East Port Water Reclamation Facility Expansion

**CCU Change Order Request**  
**East Port WRF Expansion - CCU File # 18-0006**  
**Change Order 2**

**PROPOSED CONTRACT MODIFICATION (PCM) No. 19**

CONTRACT DOCUMENT REFERENCE(S): Attached sketch Sheet E37

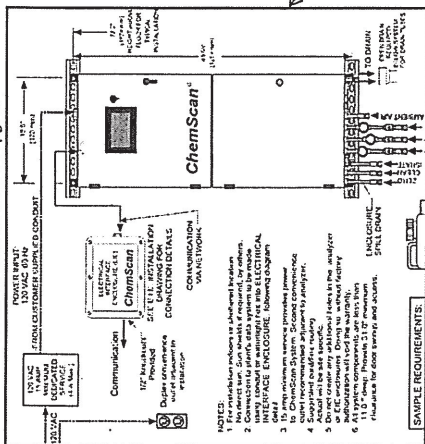
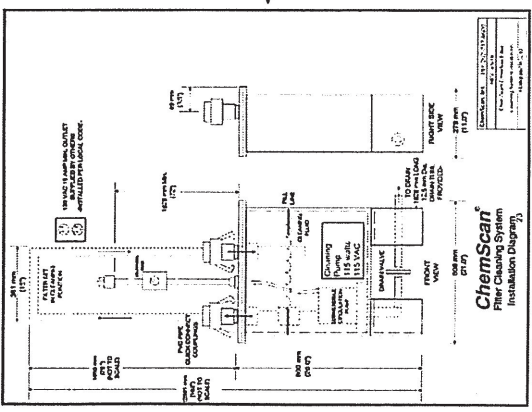
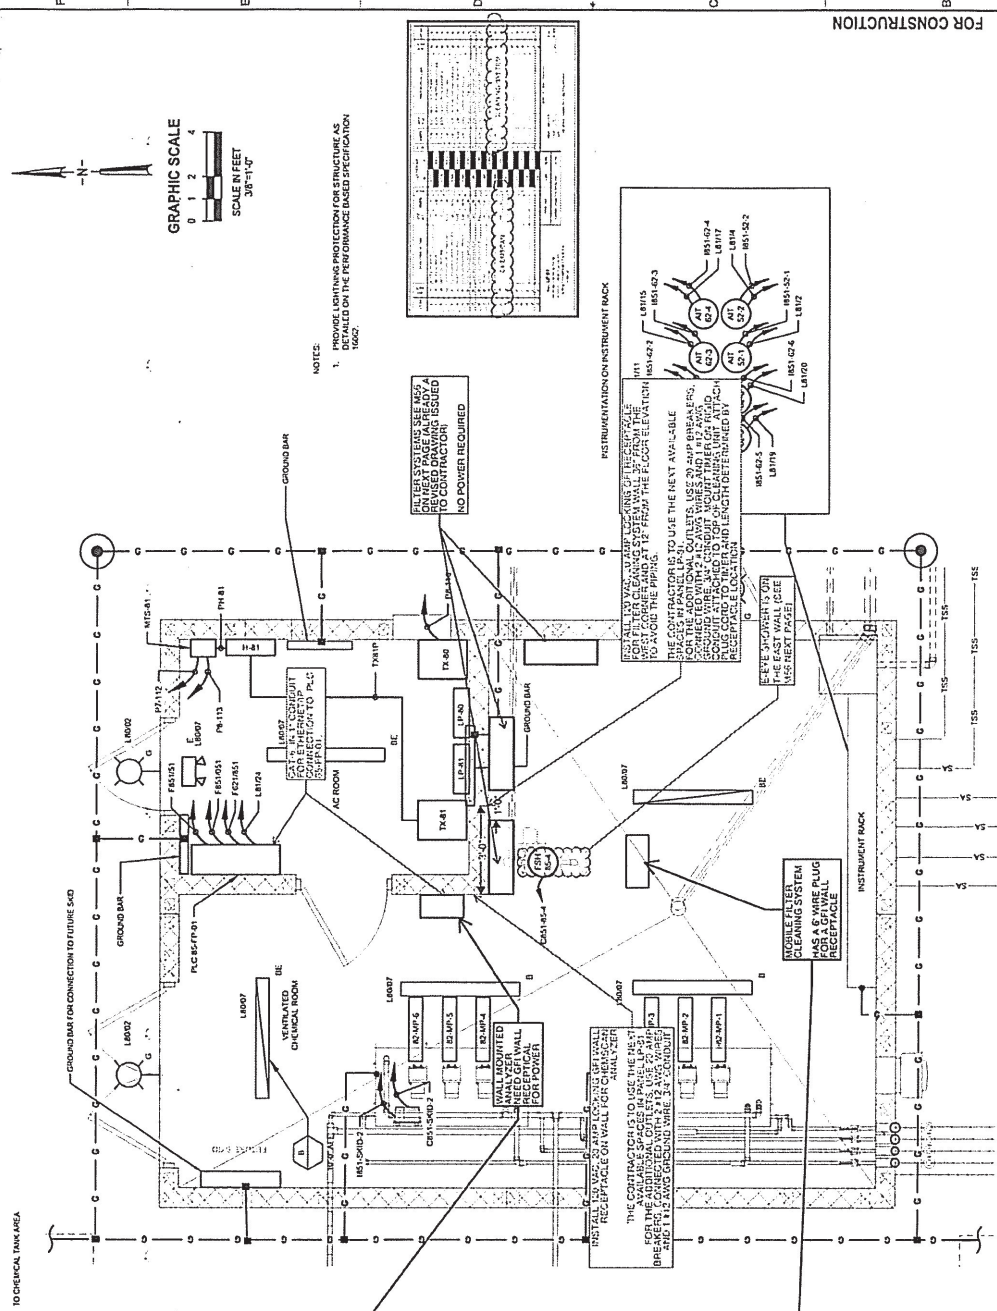
Furnish and install (2) 120 Volt GFCI Receptacles from local panel indicated in the attached drawing.

REASON FOR MODIFICATION: Required power supply for Analyzer and Filter units.

CHEMICAL FEED ROOM ELECTRICAL PLAN

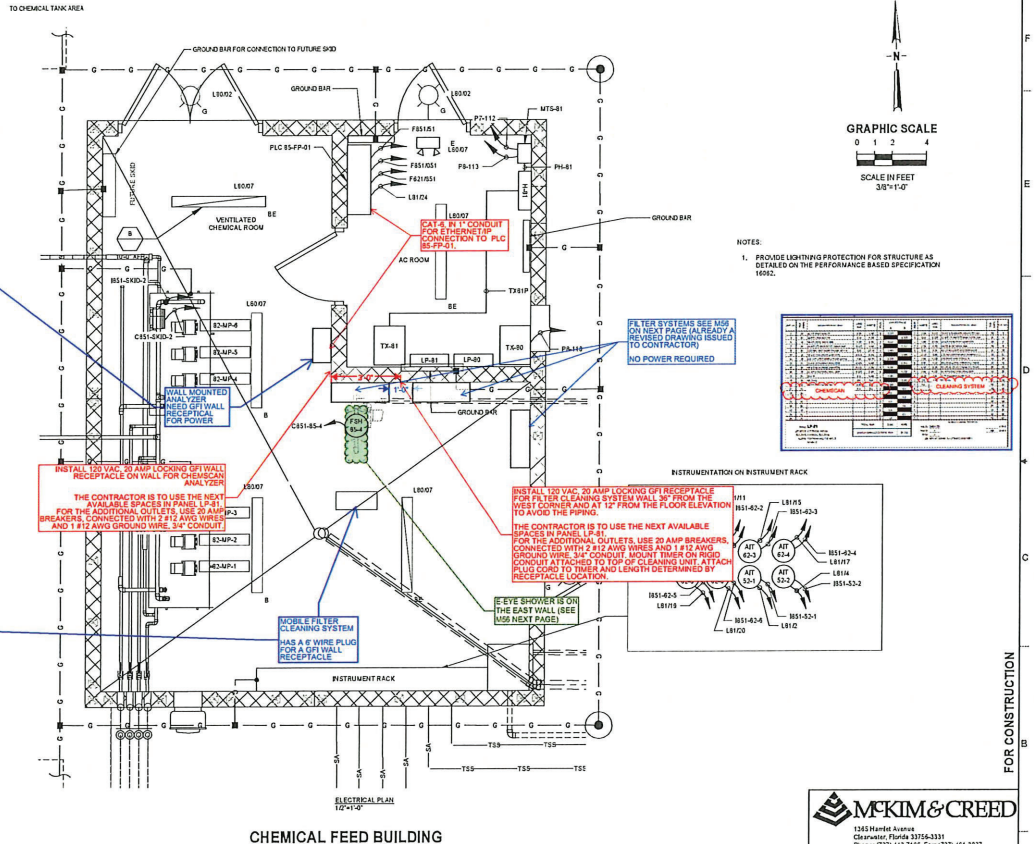
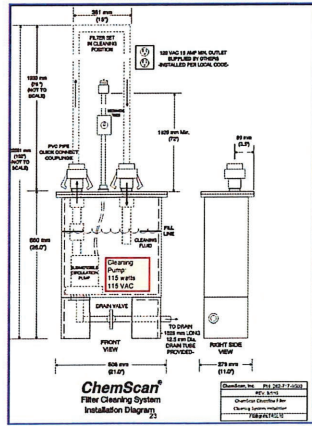
Furnish and install (2) 120 Volt GFCI Receptacles from local panel indicated in the attached drawing.

REASON FOR MODIFICATION: Required power supply for Analyzer and Filter units.

CONTRACT DOCUMENT REFERENCE(S): Revised Markup of Drawing Sheet M-56

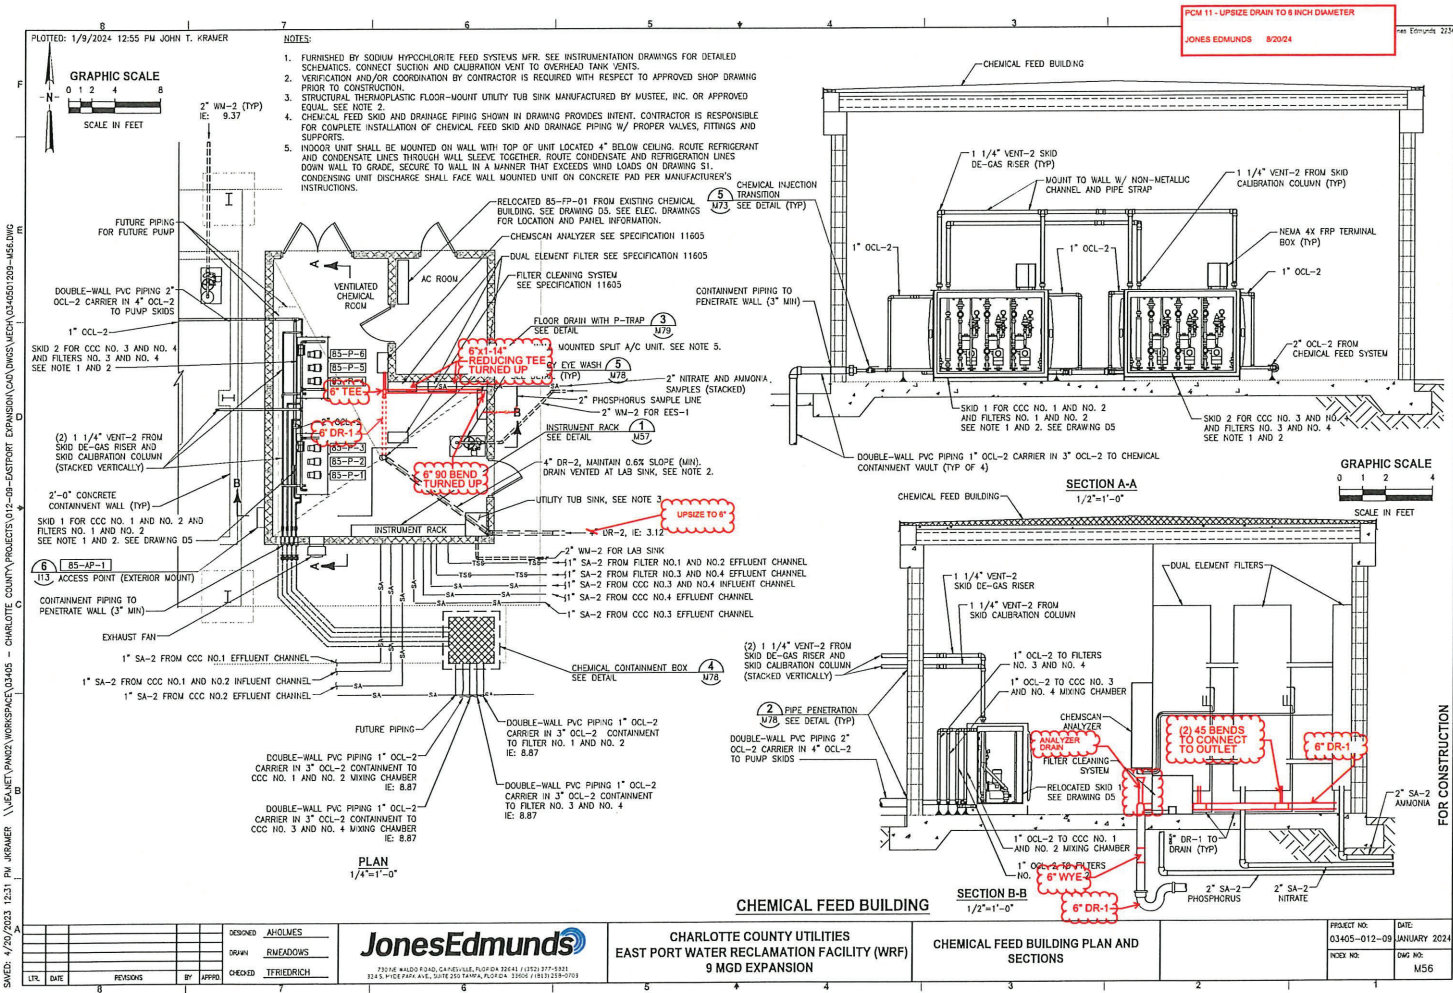
- Upsize drainpipe diameter to 6-Inch as shown per attached Sheet M-56 in the Chemical Feed Building.

REASON FOR MODIFICATION: To accommodate submitted Analyzer process stream.
